## INFORMATION REQUEST

**INFORMATION REQUEST #:** IR-006-24

**TOPIC:** Mohr Avenue Improvements

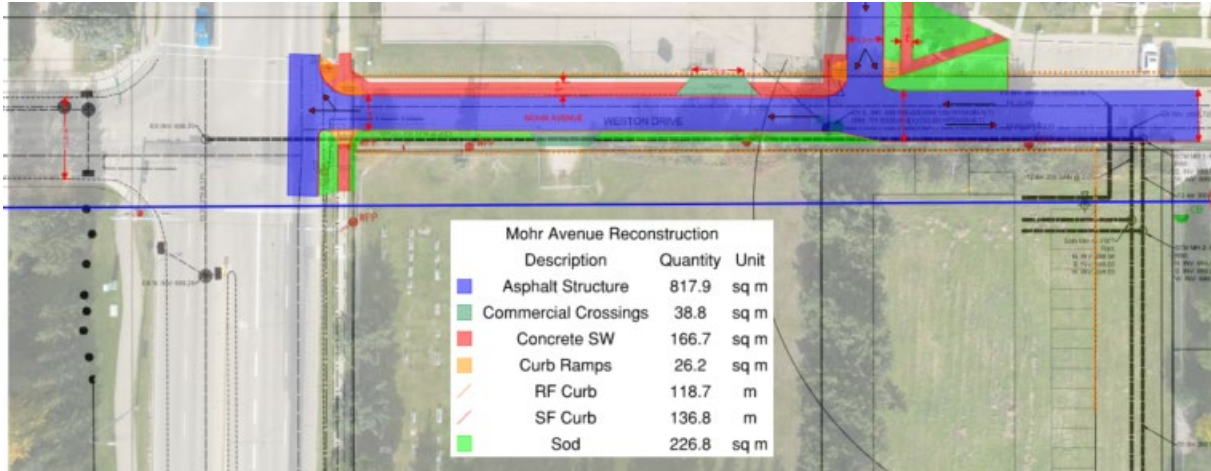
Engineering to provide more information regarding Mohr Avenue and whether the improvements will result in the 'alley' becoming a full 'road' with thru traffic to the City Centre.

After, reviewing the preliminary design for Mohr Avenue it is confirmed that Mohr Avenue will be a one way road. The reason for the one way is that the current road width would not allow for two directional traffic and there was no ability to widen the road due to the developments (cemetery) bordering the road. The one way will be west bound only and will start at the new Meridian access along Mohr.

The diagram below provides a visual of how the road will look and function once work is complete.
